Release note

Dual Lens Tracking Camera: TR535/TR535N

<p>FW version</p>	<p>V0.0.0000.26</p>													
<p>Release date</p>	<p>2025/03/25</p>													
<p>New Feature</p>	<ol style="list-style-type: none"> <p>NDI is now built into the TR535 with this firmware update. After updating the firmware, if the NDI page is not visible on the webpage, please log out and log back in to access the NDI configuration settings.</p> <div data-bbox="322 734 1289 1003" data-label="Image"> </div> <p>Power Mode add one more feature "ERP" to let camera under 0.5W at standby mode, this is for ESG strategy.</p> <div data-bbox="322 1173 1315 1424" data-label="Image"> </div>

Remote Control

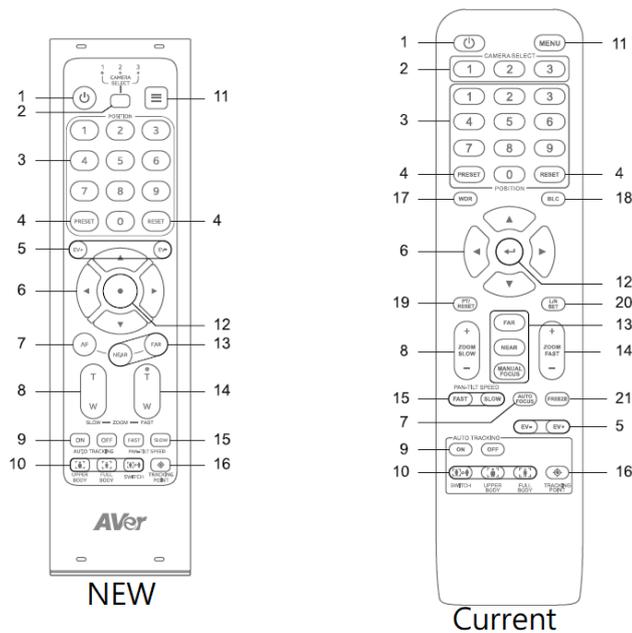
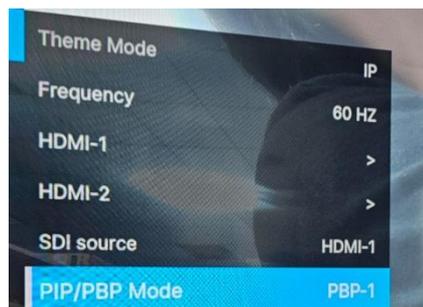
2. Added "P/T Reset" and "Panning Direction (L/R Set)" to the Web Interface and OSD Manual to prepare for the new remote control rollout in Q2, we have added the "P/T Reset" and "Panning Direction (L/R Set)" options to the web interface and OSD manual. The new remote control features a simpler design, removing two buttons and relocating their functions to the web interface and OSD manual. Both the current and new remote controls will be fully compatible with the camera. Please see the new remote control design below.

Your device may come with one of the following remote controls.

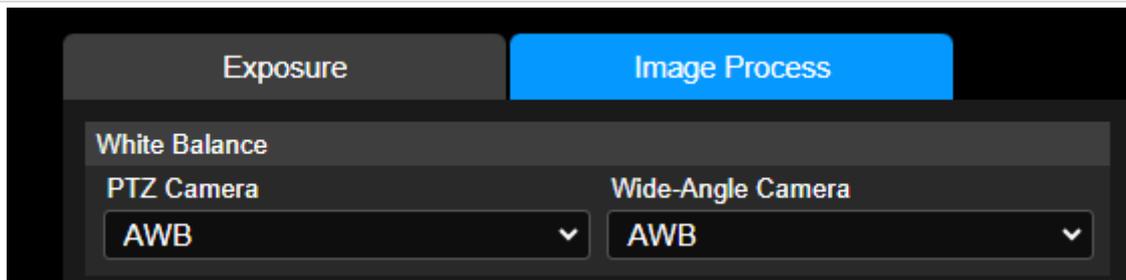
3. Bug fix: Correct the feature name from PIP to “PIP/PBP” on OSD menu.
